SUBJECT: ISSUANCE OF AMENDMENTS - McGUIRE NUCLEAR STATION, UNITS 1
AND 2 (TAC NOS.MA1143 AND MA1144)

The amendments revise Figure 5.1-1 of the TS to show the new location of the meteorological tower. The meteorological tower will be relocated to a new location to facilitate use of the current location as a construction site. The proposed TS change does not change the related TS Section 5.1.1.

SAFETY EVALUATION BY THE OFFICE OF NUCLEAR REACTOR REGULATION
RELATED TO AMENDMENT NO. 179 TO FACILITY OPERATING LICENSE NPF-9
AND AMENDMENT NO. 161 TO FACILITY OPERATING LICENSE NPF-17

MCGUIRE NUCLEAR STATION, UNITS 1 AND 2

FIGURE 5.1-1

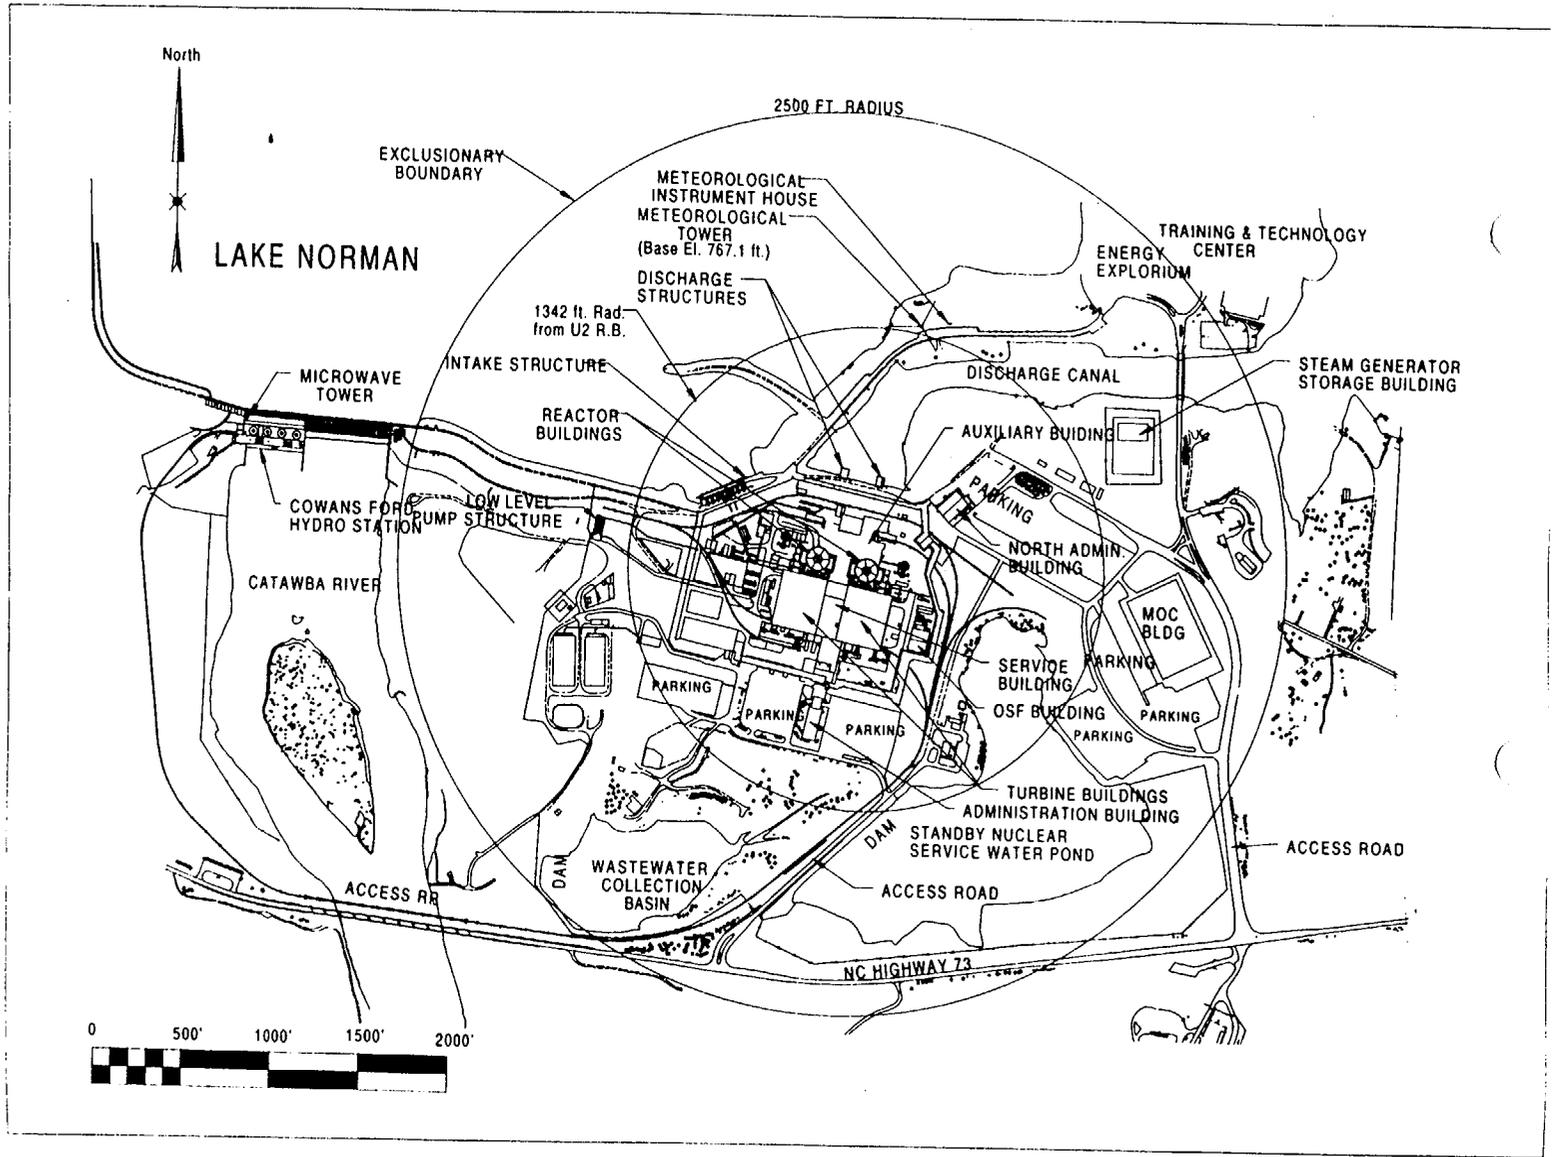
The amendments revise Figure 5.1-1 of the TS to show the new location of the meteorological tower. The meteorological tower will be relocated to a new location to facilitate use of the current location as a construction site. The proposed TS change does not change the related TS Section 5.1.1.

Replace the following page of the Appendix "A" Technical Specifications with the enclosed page. The revised page is identified by amendment number and contains vertical lines indicating the areas of change.

The licensee plans to remove the current meteorological tower from its location west of the reactor plant complex and construct a new tower at a location generally north of the plant complex on a strip of land between Lake Norman and the plant discharge canal. To obtain meteorological information required for a valid estimate of atmospheric diffusion in the vicinity of a nuclear power plant site, the meteorological instruments should be sited to adequately represent overall site area conditions and minimize possible influences from local features. The licensee has considered several locations prior to selection of the proposed location. One location is in an open area, but does not provide adequate space for placement of guy lines needed to secure the tower and is not in a secured area. A second location is in an area where the topography slopes down into a river valley and could be subject to localized air flows.

The proposed tower location is an open area on the bank of Lake Norman north of the reactor buildings. The licensee has stated that this location meets the guidelines of Section C.2, "Siting of Meteorological Instruments," of Regulatory Guide 1.23, "Onsite Meteorological Programs." The new tower will be sited at approximately the same elevation as finished plant grade and in an area where plant structures will have little or no influence on the meteorological measurements. As a result of removing trees along the shore of Lake Norman, the tower will be sited in an open area that is at least 10 obstruction heights away from natural or man-made obstructions. This relatively flat area has an exposure to Lake Norman whose presence dominates the ambient meteorology in the McGuire site vicinity. At the new location the tower

FIGURE 5.1-1

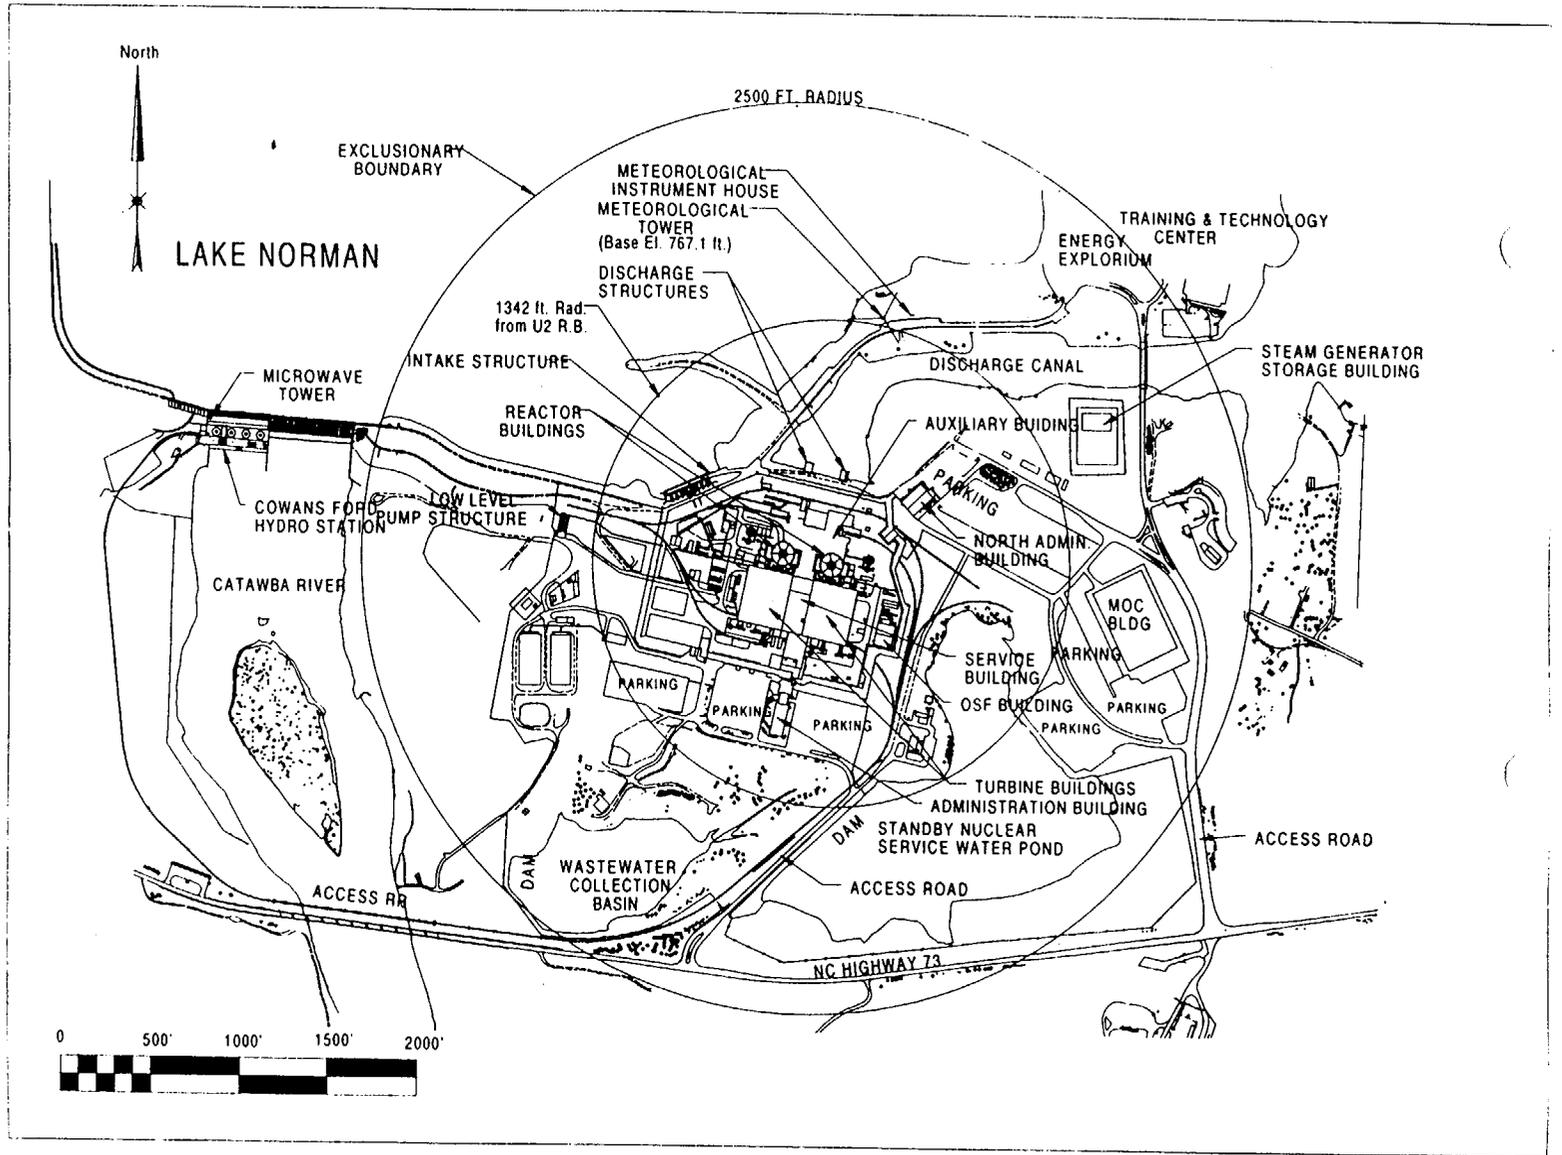
Replace the following page of the Appendix "A" Technical Specifications with the enclosed page. The revised page is identified by amendment number and contains vertical lines indicating the areas of change.
